Revisions and Errata List
AISC Steel Design Guide 11, 2nd Edition, 1st printing (Printed Copy)
September 10, 2019

The following list represents corrections made to the first printing (dated May 2016) of the second edition of AISC Design Guide 11, *Vibrations of Steel-Framed Structural Systems Due to Human Activity*.

Fig. 7-17. Predicted FRF magnitudes, Example 7.2.

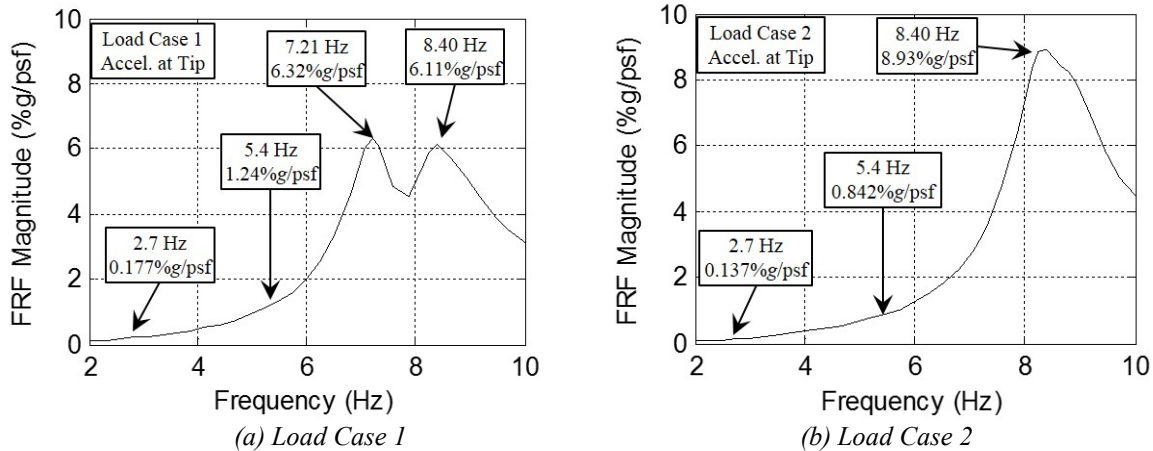
104 Replace Figure 7-17 with the following:
